# **Mount Piper to Wallerawang Transmission Line Upgrade Project**

Amendment Report

December 2025

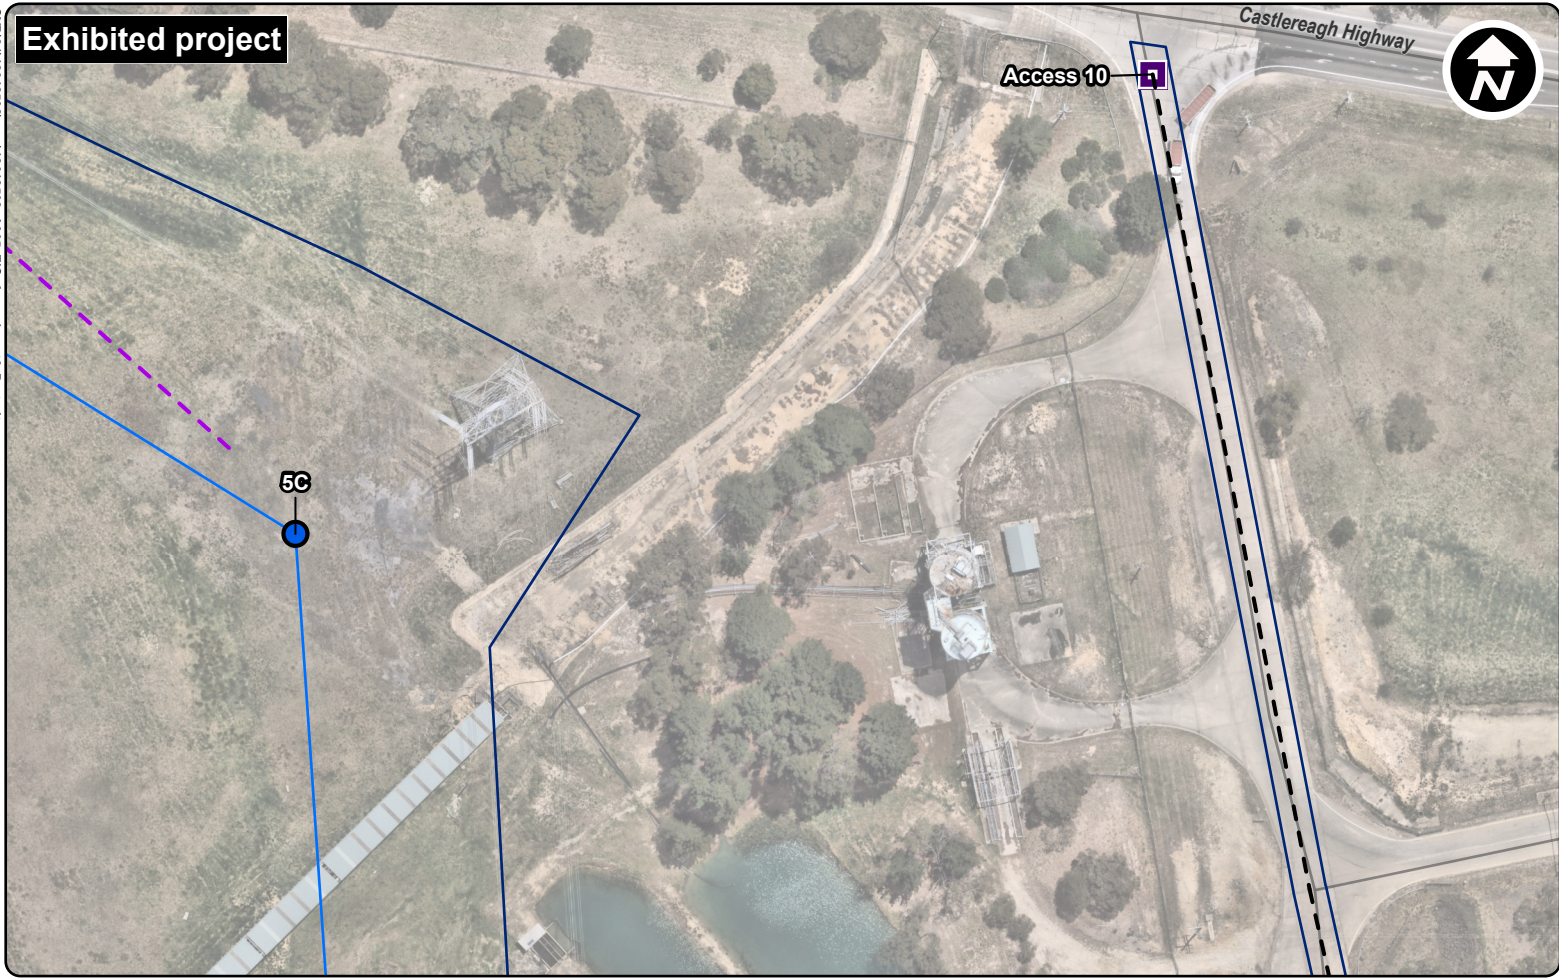
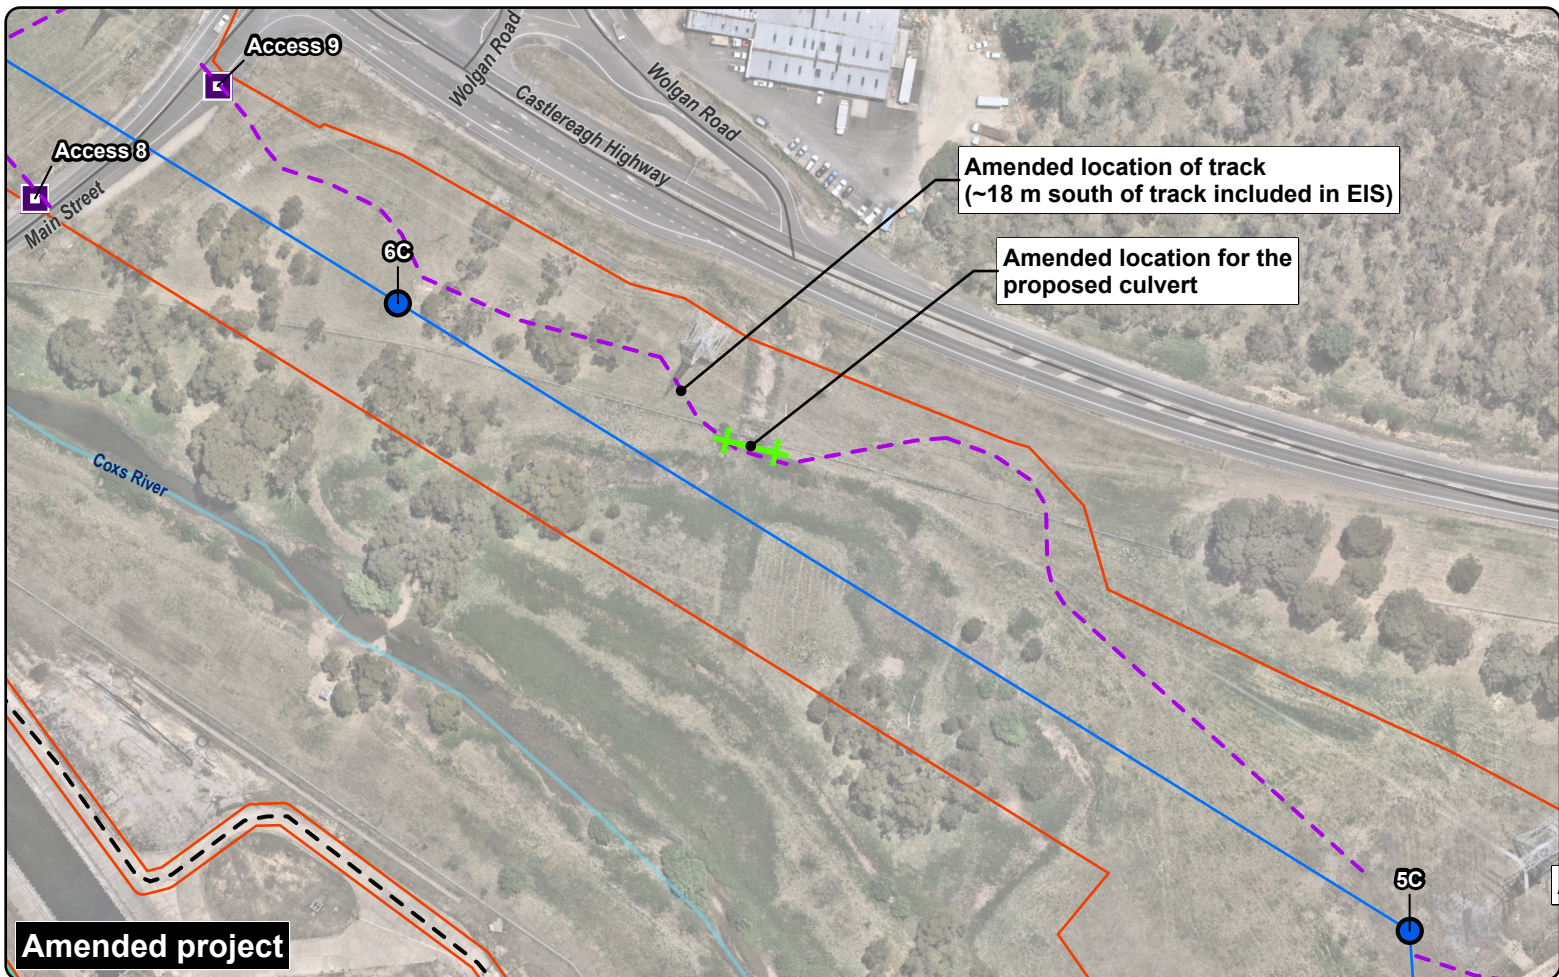
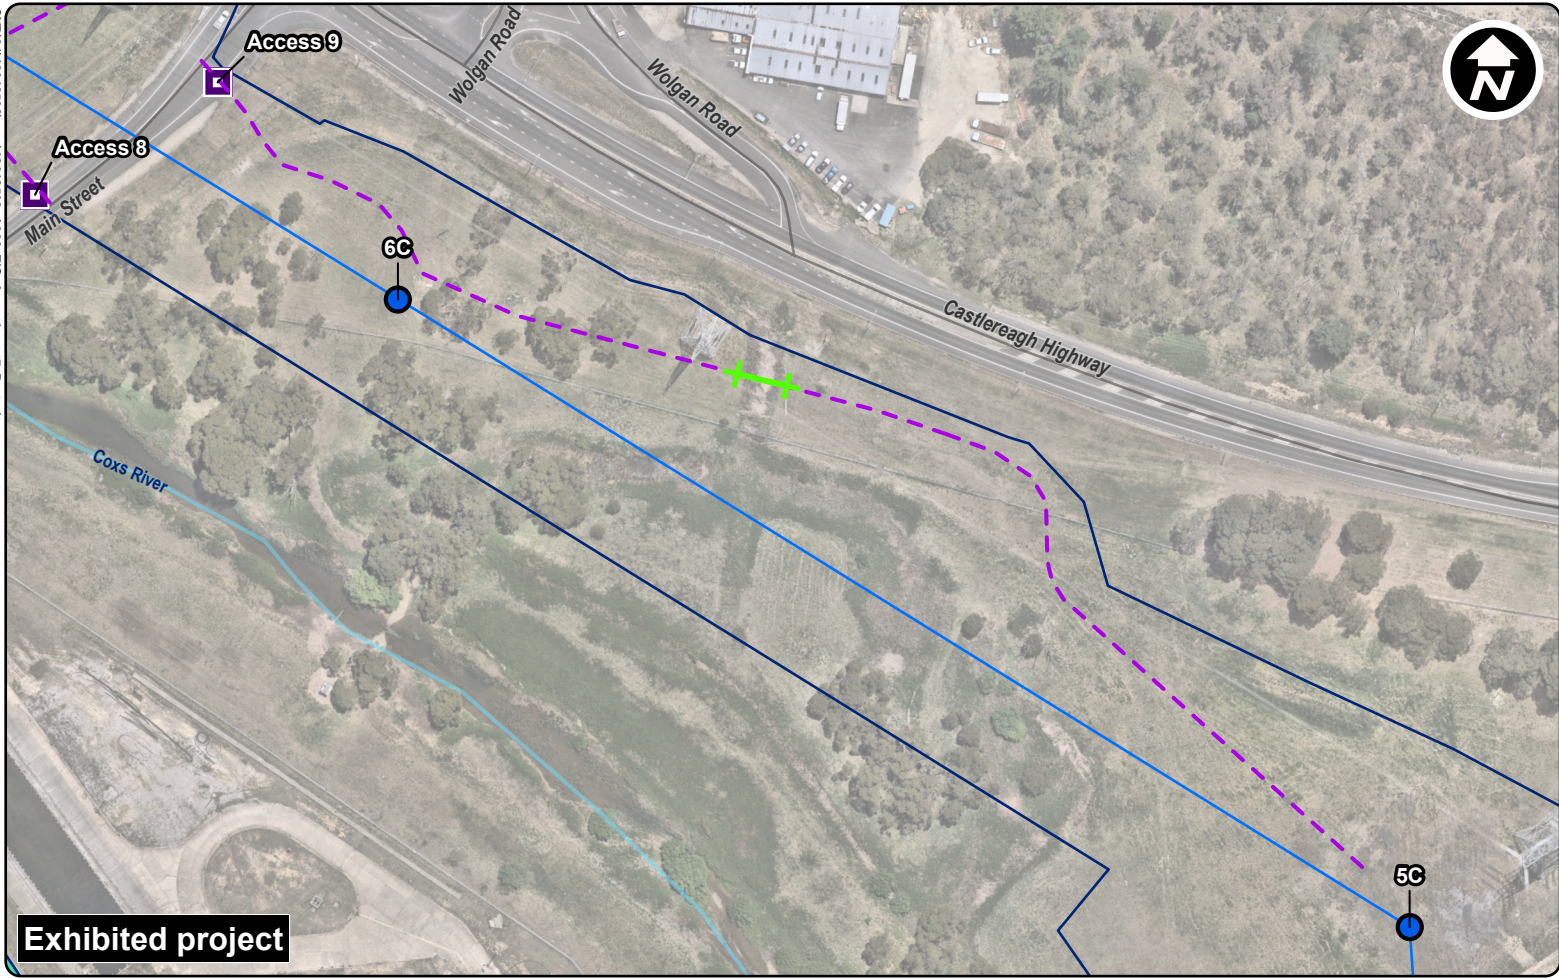
No.	Proposed amendment	EIS description	Amendment description	Reason for amendment	Figure reference
6	Additional new access track to TS5C from the east	Access to TS5C was proposed via an access track from the west via access point 9 which also provided access to TS6C. This new track included a new culvert over the permanently wet area located between TS5C and TS6C.	An additional new access track to TS5C is proposed from the east. The new track would be accessed from the proposed track at access point 10. The new access track would require construction of about 120 m of new track, 6 m in width, and use about 60 m of existing tracks/ hardstand areas.  Construction of the new section of track would involve the removal of two trees consisting of one planted native ( <i>Eucalyptus viminalis</i> ) and one planted exotic (pine tree).	The additional new access track would avoid the low lying and wet area located between TS5C and TS6C.	Figure 2.6

Figure 2.7 Amendment 7 - Amendment to access track to TS5C from the west

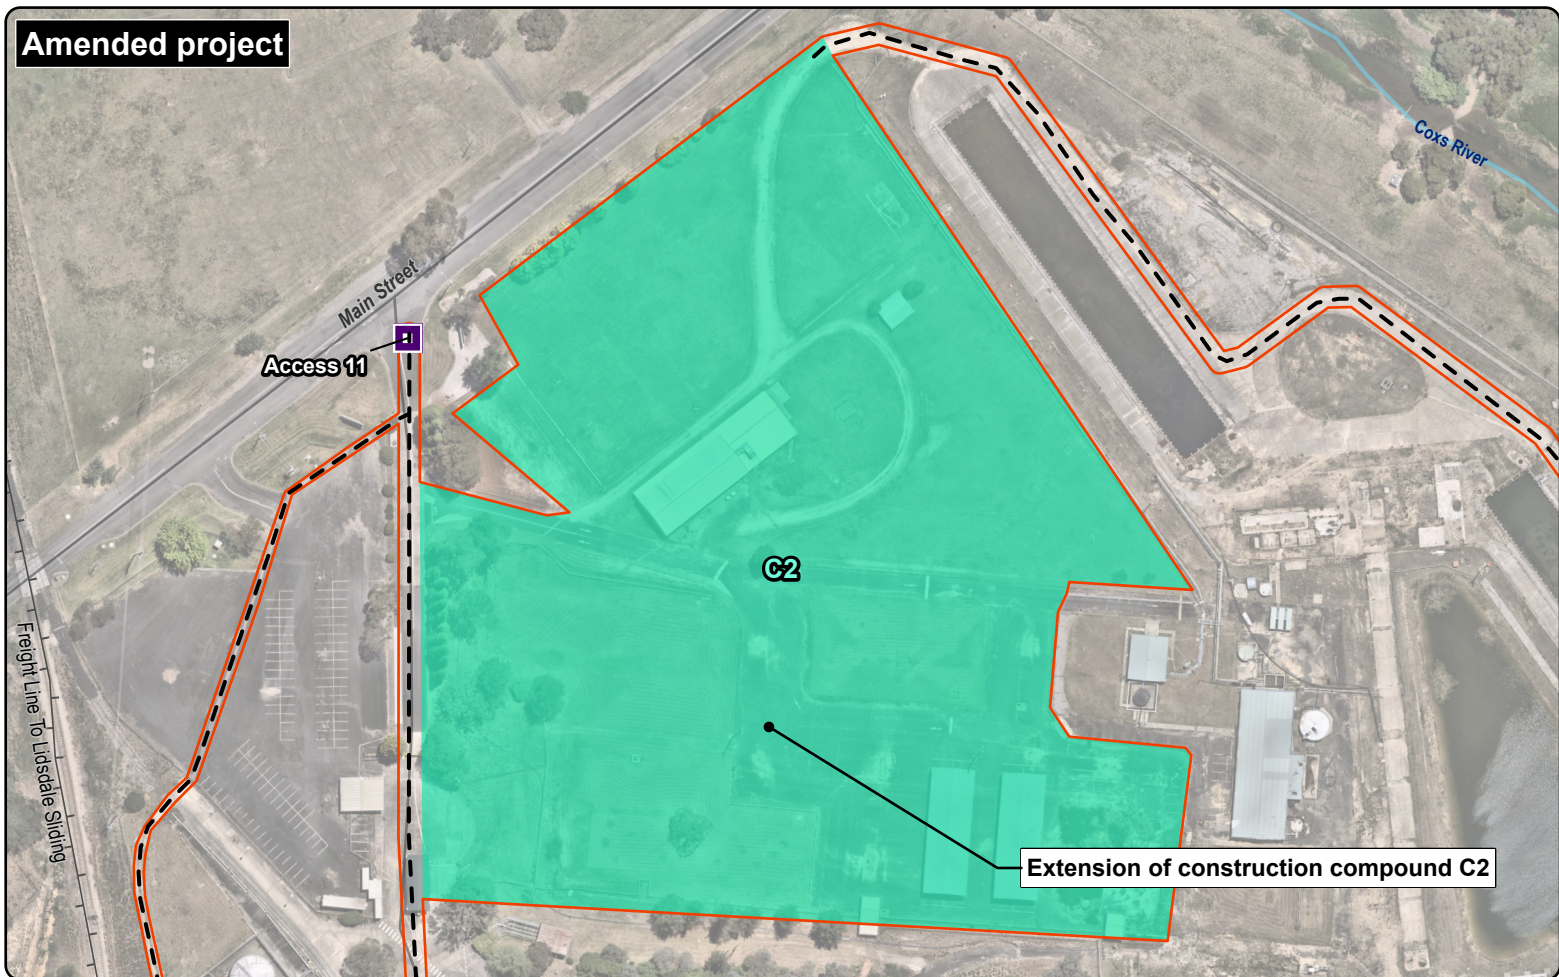
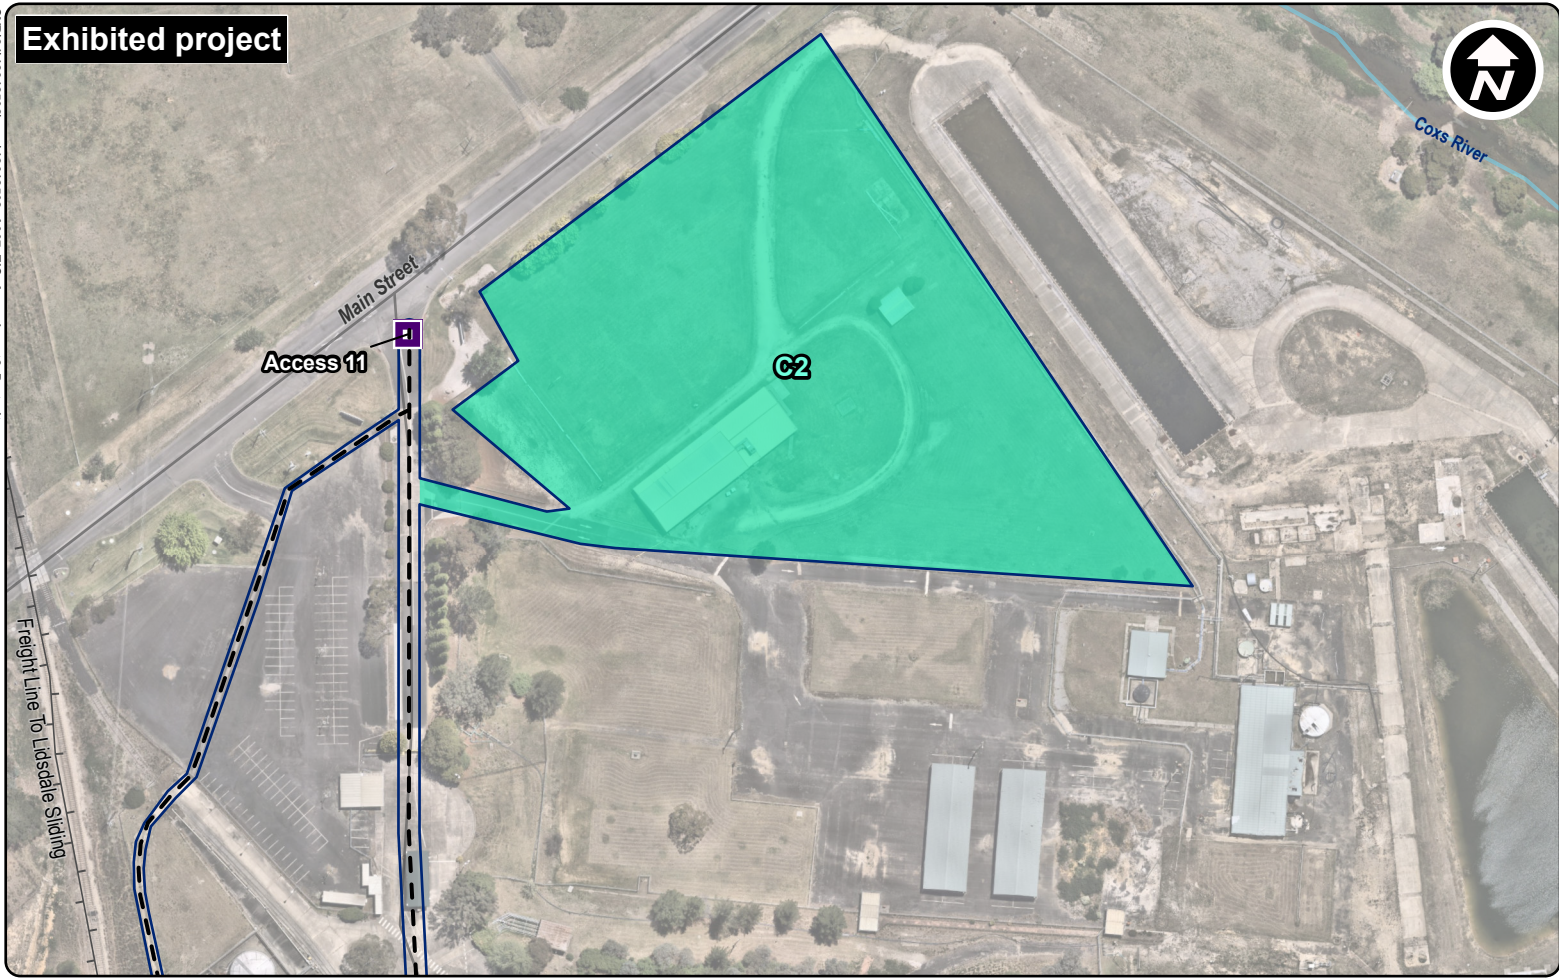
7	Amendment to access track to TS5C from the west	Access to TS5C was proposed via an access track from the west via access point 9 which also provided access to TS6C. This track included a new culvert over the ephemeral drainage line located between TS5C and TS6C.	About 80 m of track would be shifted south to better position the proposed culvert location. The access track and the culvert would remain within the EIS project footprint. No tree clearing would be required.	The amended alignment would avoid the low lying and wettest area west of TS5C.	Figure 2.7
8	Extension of construction compound C2	Construction compound C2 located adjacent to and south of Main Street, occupying an approximate area of 1.8 ha.	Construction compound C2 would be expanded to the south requiring about 2 ha of additional land.  The expanded area includes existing grass and hardstand areas, some trees and demountable structures. The grass would be removed and re-instated post-construction. No tree clearing would be required and the demountable structures would be retained for use.	Construction compound C2 has been expanded to allow for the option of using only construction compound C2 rather than both construction compounds C2 and C3.  The shift to a single compound would minimise vehicle movements through the property, which was raised as a concern by the landowner.	Figure 2.8

**Figure 2.9 Amendment 9 - Use of additional existing track to access construction compound C3**

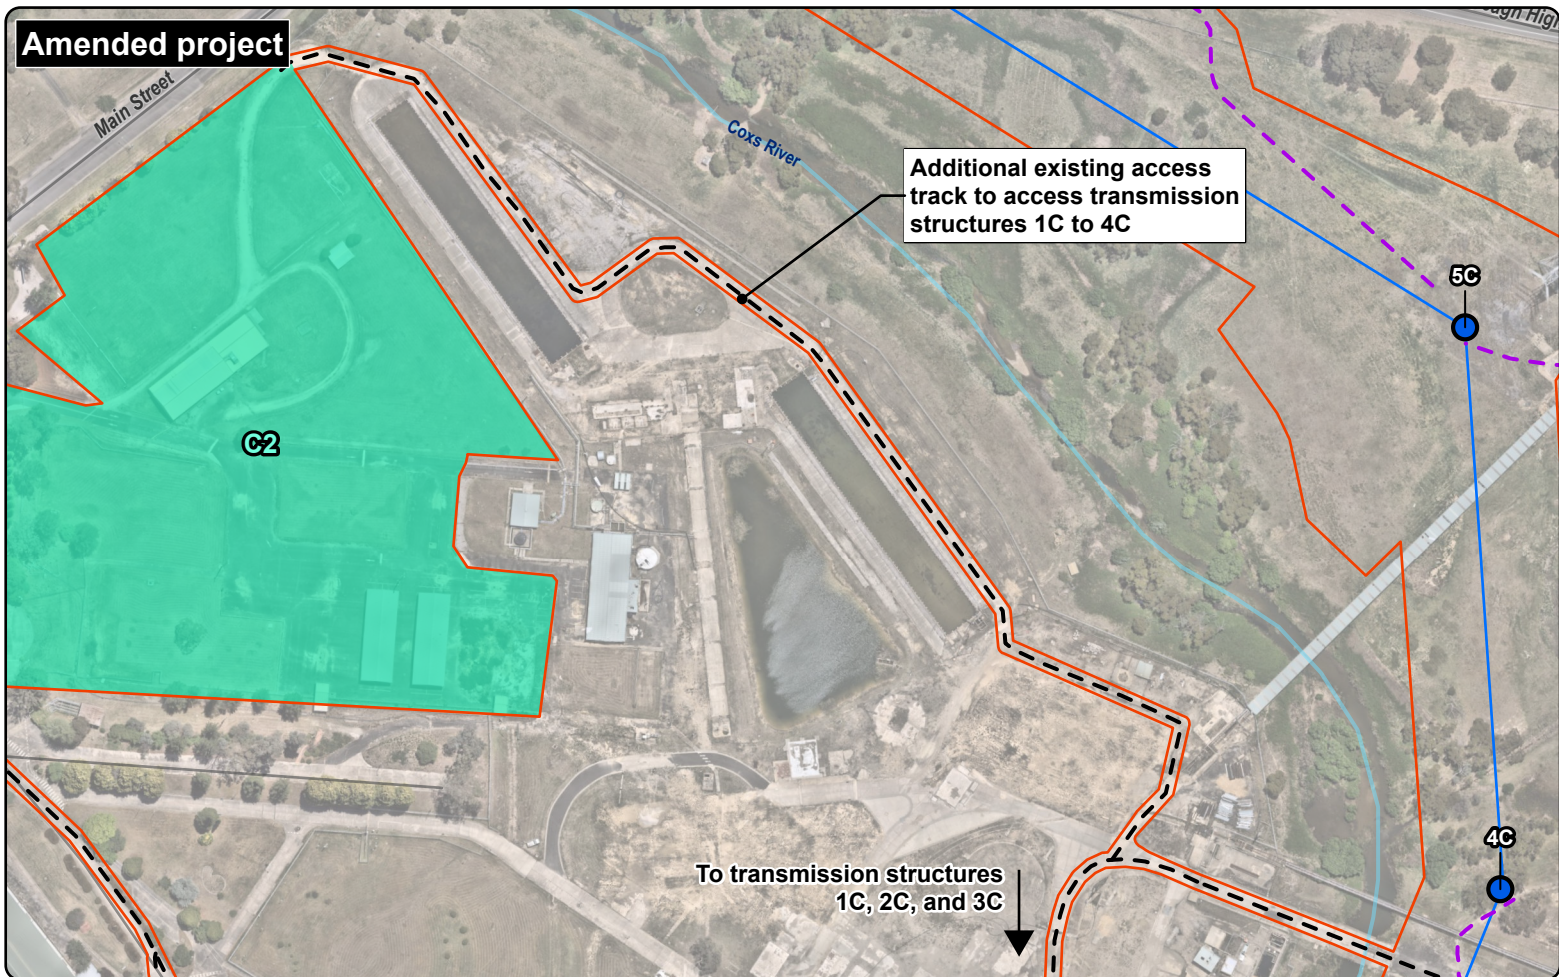
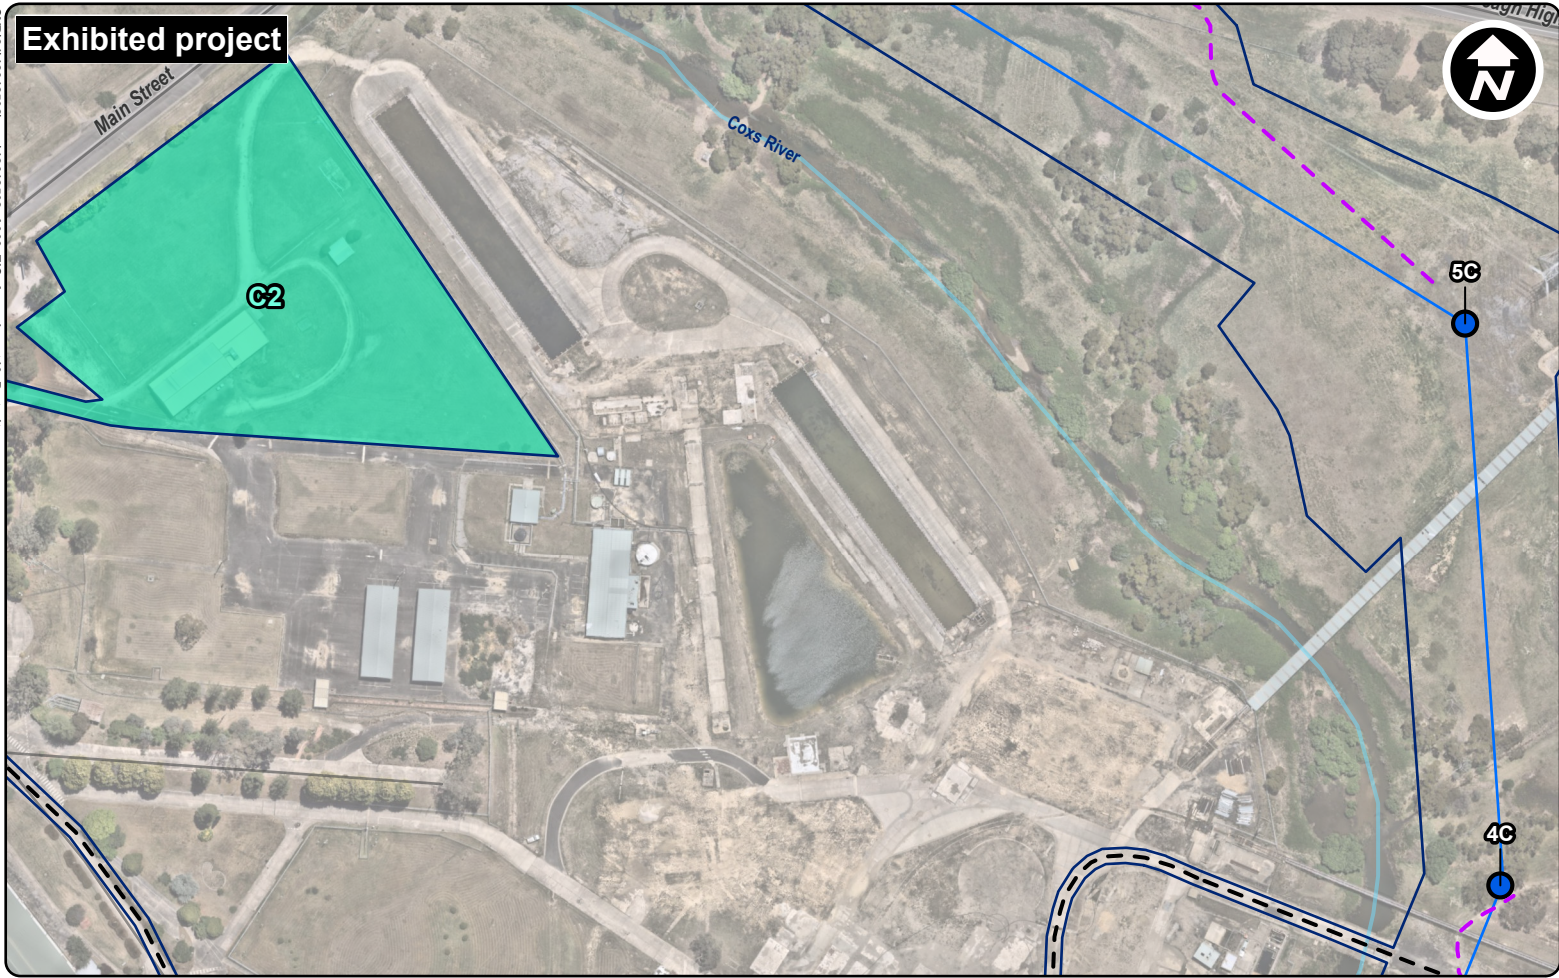
9	Use of additional existing track to access construction compound C3	Construction compound C3 was proposed to be accessed from the existing internal access track along the northern boundary of the compound.	An additional access point at the western boundary to construction compound C3 is proposed, via an existing access track. The track would not require upgrades.	This change is the result of outcomes from further landowner consultation and review of construction efficiencies relating to compound use and access.	Figure 2.9
